PROPOSAL FOR DRAFT AMENDMENTS TO REGULATION No. 100

UNIFORM PROVISIONS CONCERNING THE APPROVAL OF VEHICLES WITH REGARD TO PROTECTION AGAINST ELECTRIC SHOCK AND OF BATTERY ELECTRIC VEHICLES WITH REGARD TO SPECIFIC REQUIREMENTS FOR THE CONSTRUCTION, FUNCTIONAL SAFETY AND HYDROGEN EMISSIONS

Annex 4 - MEASUREMENT OF THE INSULATION RESISTANCE OF A VOLTAGE CLASS B BATTERY USING ~~THE TRACTION BATTERY~~ ITS OWN VOLTAGE

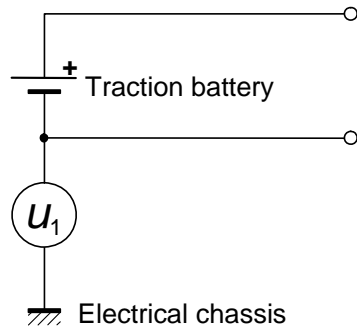
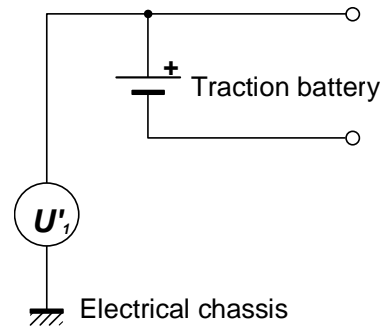
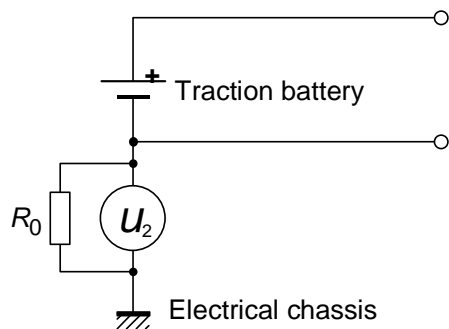
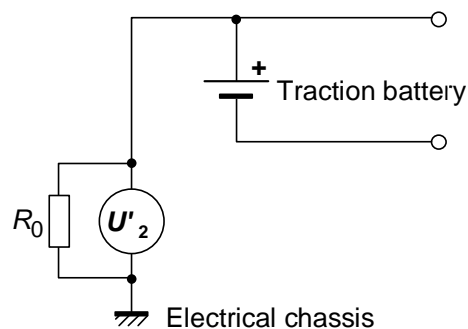
~~The traction battery shall be fully charged.~~

The voltmeter used in this test shall measure DC values and have an internal resistance greater than 10 MΩ.

Throughout the test, the traction battery shall have an open circuit voltage greater than or equal to its nominal value.

The measurements shall be performed in three steps, **as shown below.**

Step 3: measurement of U_2 (if $U_1 > U'_1$)

Step 3: measurement of U'_2 (if $U_1 < U'_1$)

NOTE R_0 is a standard resistance of between 100 Ω/V and 500 Ω/V (referred to the nominal voltage of the traction battery)

The value of the insulation R_i shall be calculated by

$$R_i = \frac{(U_1 - U_2)}{U_2} \cdot R_0$$

$$R_i = \frac{(U_1' - U_2')}{U_2'} \cdot R_0$$
